SECOND AND THIRD READING SUMMARY SHEET

ZONING CASE NUMBER: C814-2018-0121 - 218 South Lamar

ZONING CHANGE REVIEW SHEET

CASE: C814-2018-0121 -- 218 South Lamar

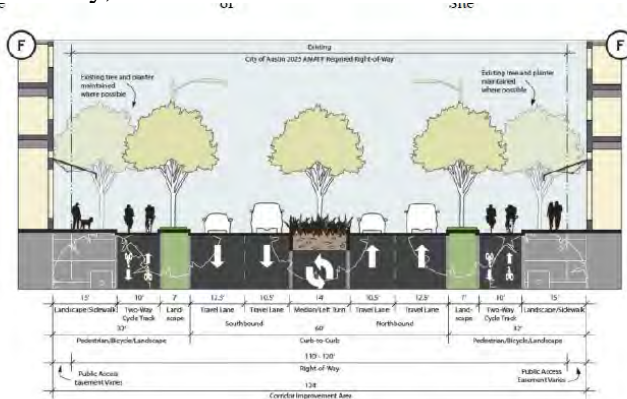
TR2. Include the below streetscape in the land use plan. Contact this reviewer for a more legible copy of it if necessary. This project is adjacent to a street that has been identified in Austin's Corridor Mobility Program (S Lamar). The sidewalk and bicycle facilities shall comply with the required cross-section at the time of the site plan application. The cross section that will be required is shown below. Find additional information about the Corridor Mobility Program here: <https://data.austintexas.gov/stories/s/Corridor-Mobility-Program/gukj-e8fh/>. Any proposed curb relocations on S Lamar requires coordination with the Corridor Planning Office and Bicycle Program. The cross section will include a 7' planting zone with street trees, a 10' two-way cycle track, and a 15' clear zone all behind curb. Additionally, a protected intersection will be required at Toomey, to be reviewed at the time of Site Plan.

4-Lane Divided, 60' Curb-to-Curb
Back-of-Curb Condition F
Barton Springs Road to Riverside Drive

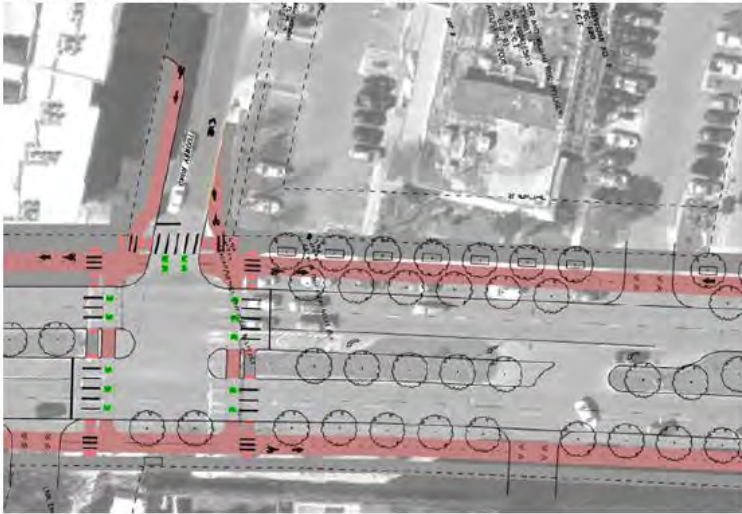
TR5. Bicycle facilities will be required along Toomey Road at the site plan stage. The design is below. Include the below graphic on the land use plan. If a more readable copy is required, contact this reviewer.

Elevator Overrun

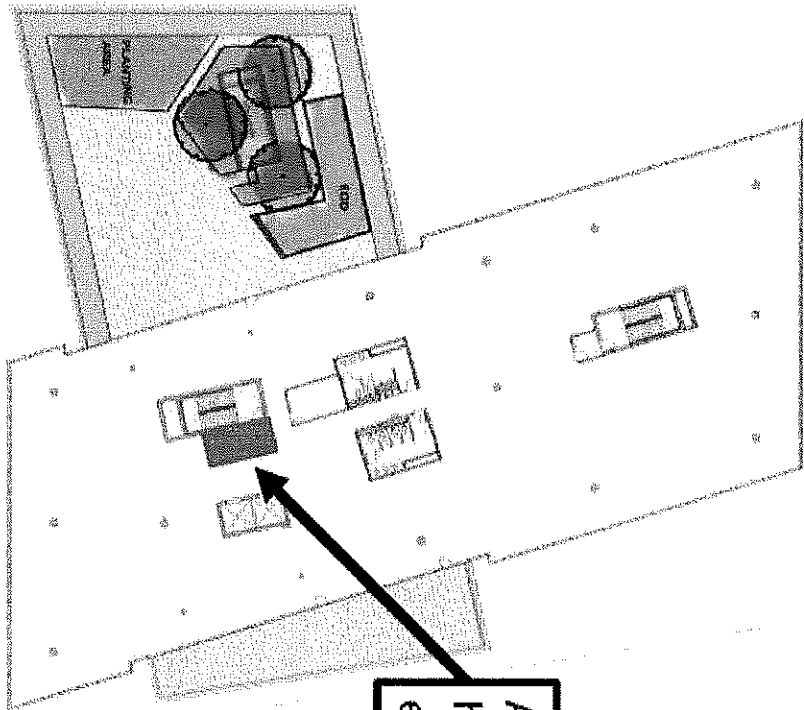
U0: Attached drawings do not show elevator over run. Please provide.

U0: Attached drawings do not show elevator over run. Please provide.

U1: Comment cleared.
